**PLANNING COMMISSION MEETING**  
**LOCATION: TOWNSHIP ANNEX, 7527 HIGHLAND ROAD, WHITE LAKE, MI 48383**  
**THURSDAY, JUNE 04, 2026 – 6:30 PM**

Project Name: Mack Industries  
 Description: Preliminary and final site plan approval  
 Date on Agenda this packet pertains to: June 4<sup>th</sup>, 2026

**RE: Mack Industries Addition - Preliminary Site Plan Review- 2<sup>nd</sup> Review  
-Final Site Plan Review-1<sup>st</sup> Review**

DRAWING NUMBER:  
**L-1.0**

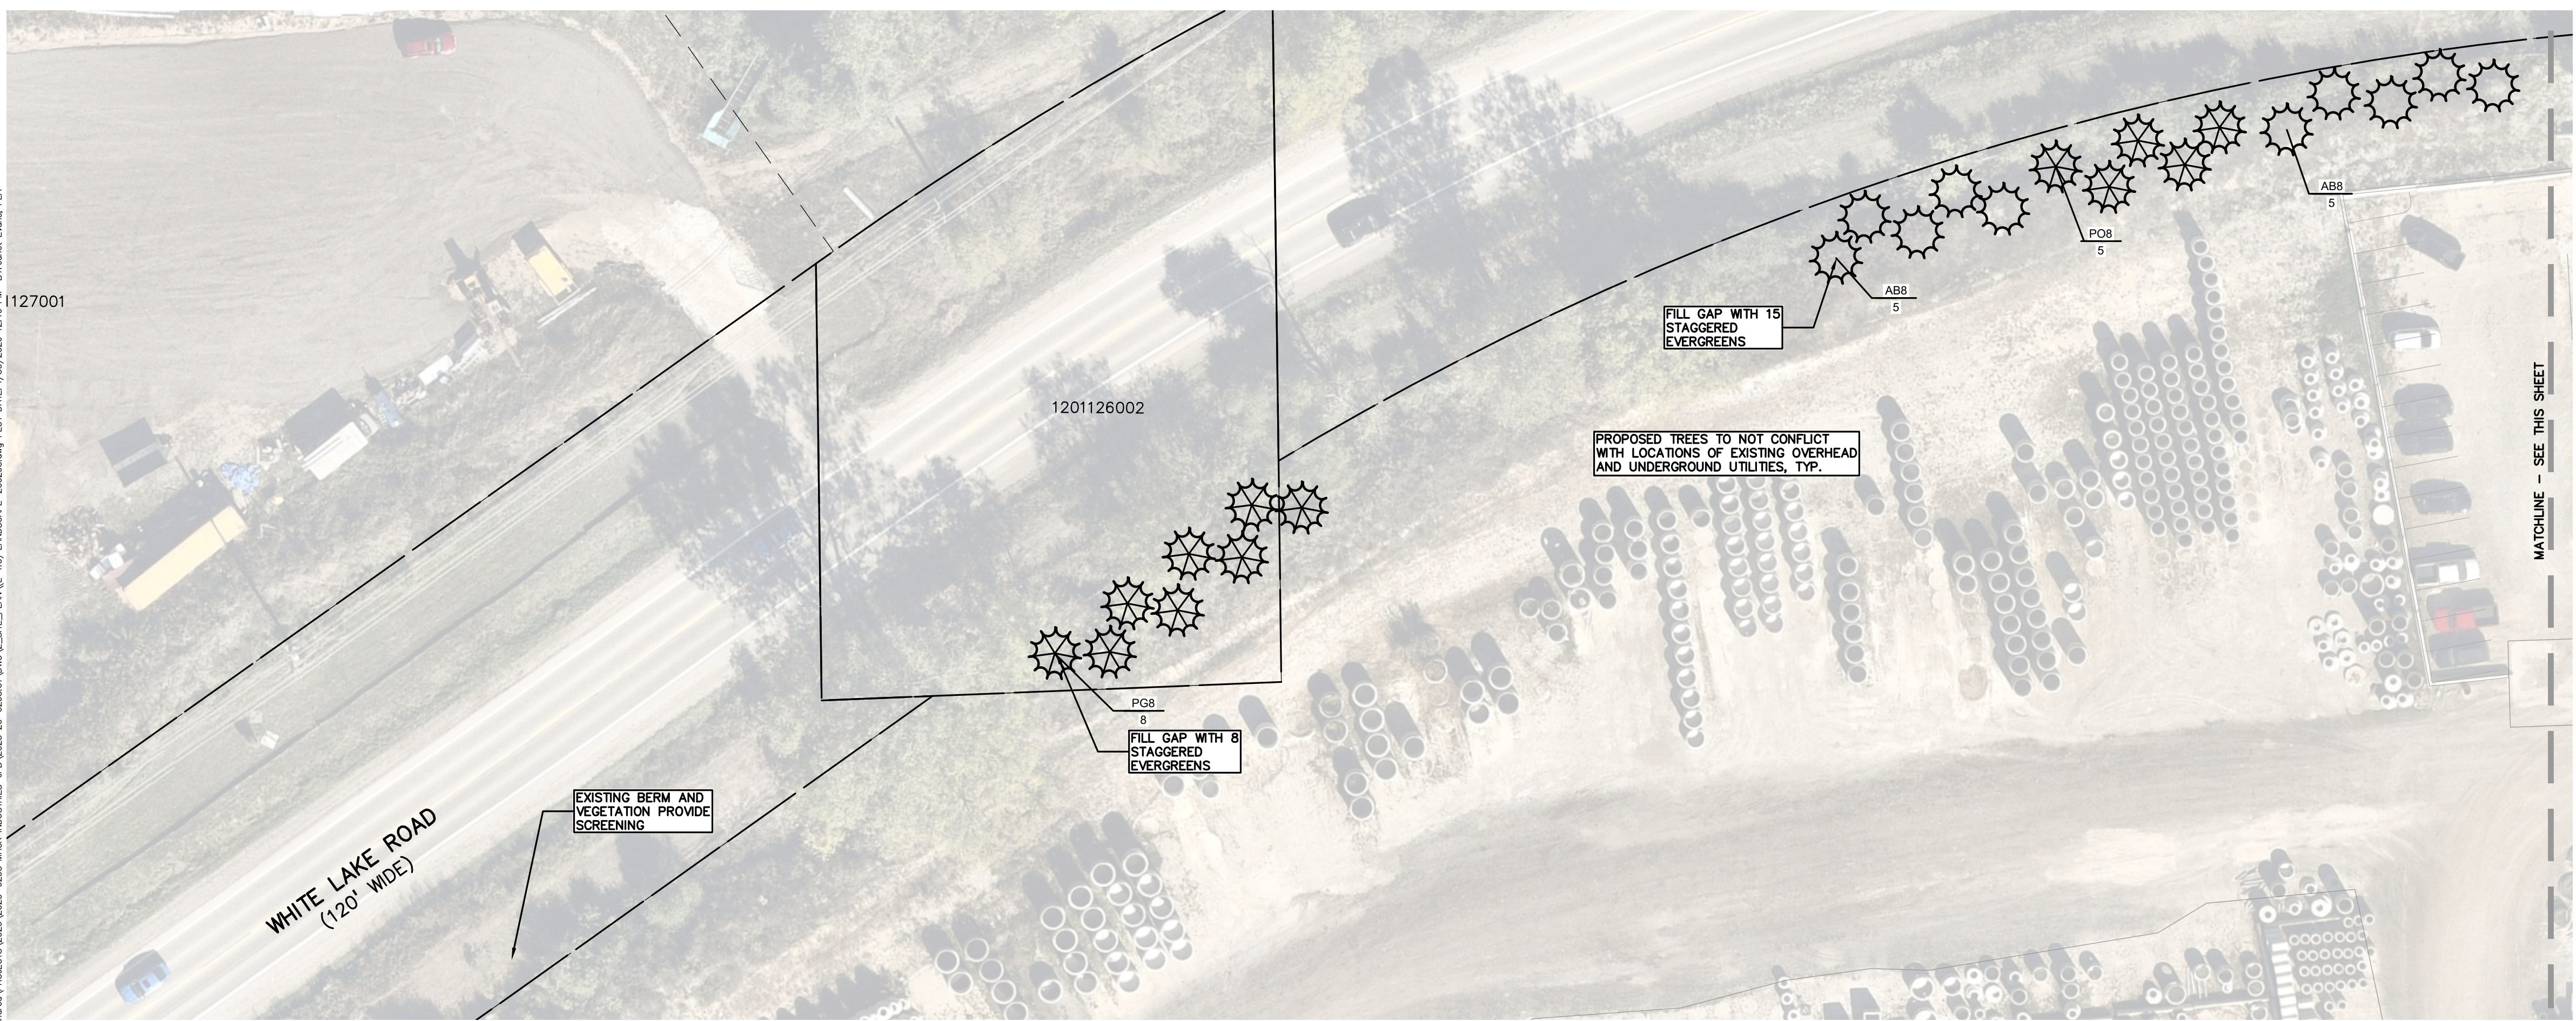
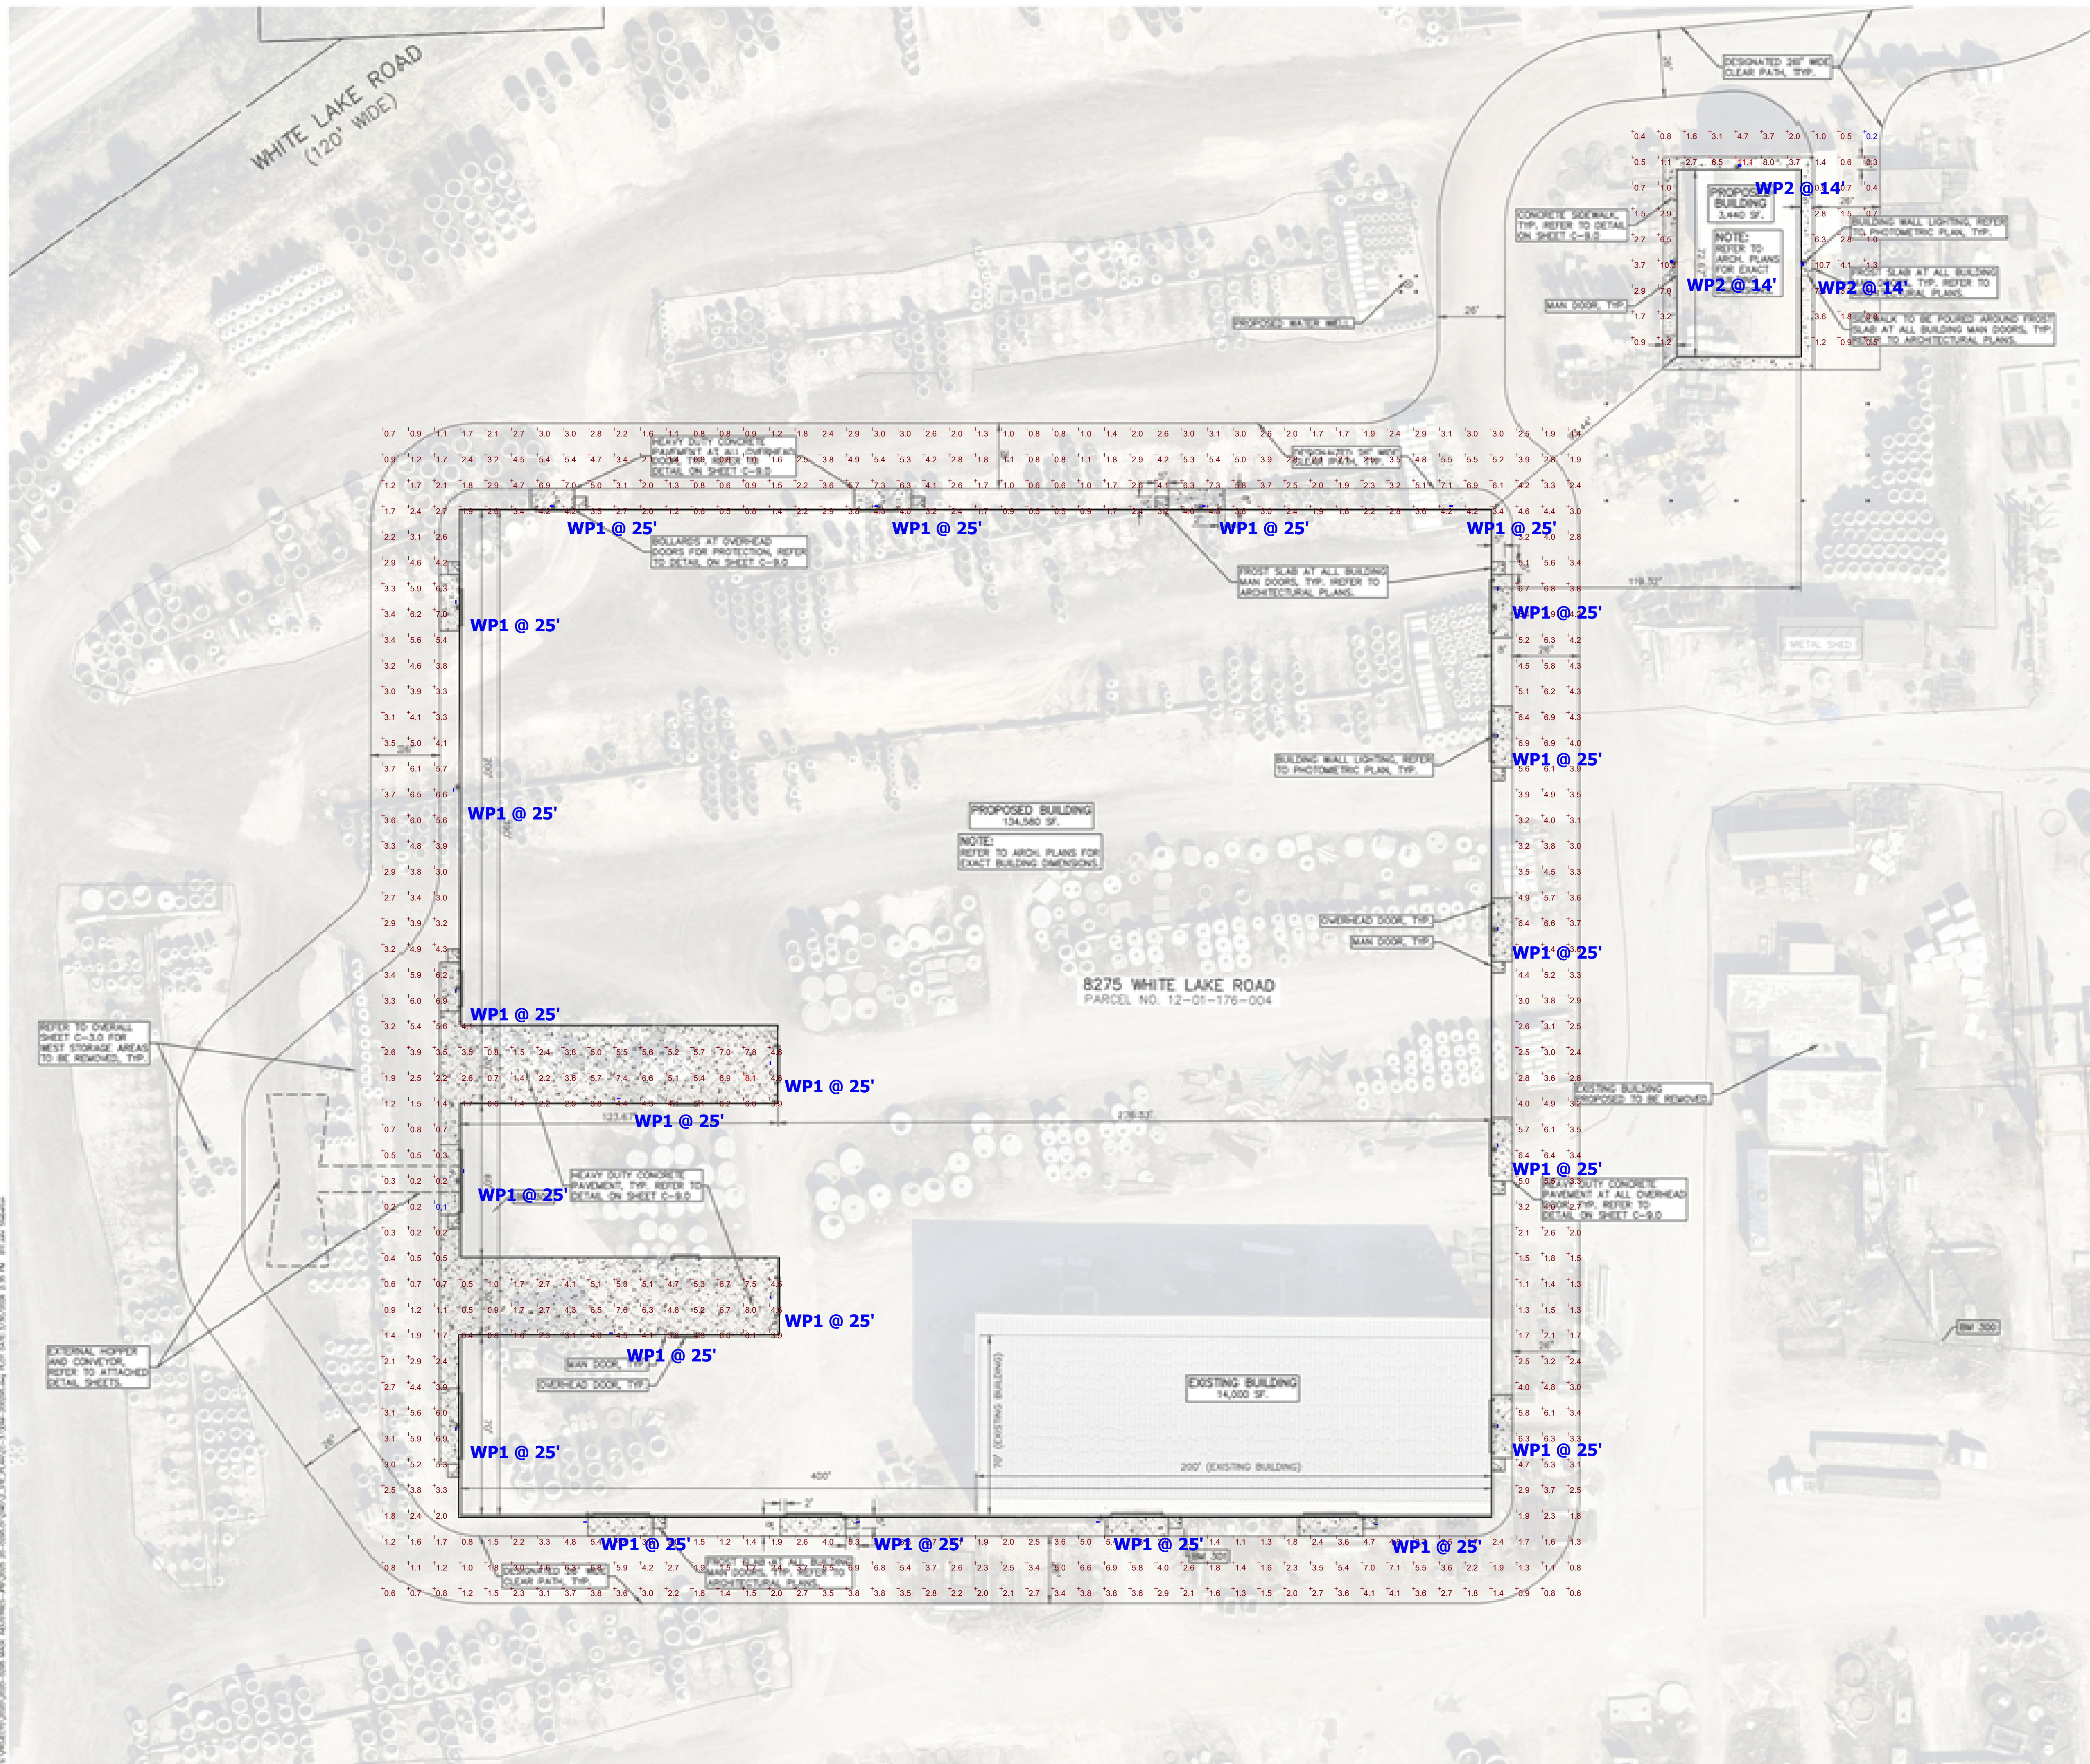
Sheets C-10.0 and L-1 provide information regarding proposed landscaping screening along White Lake Road.
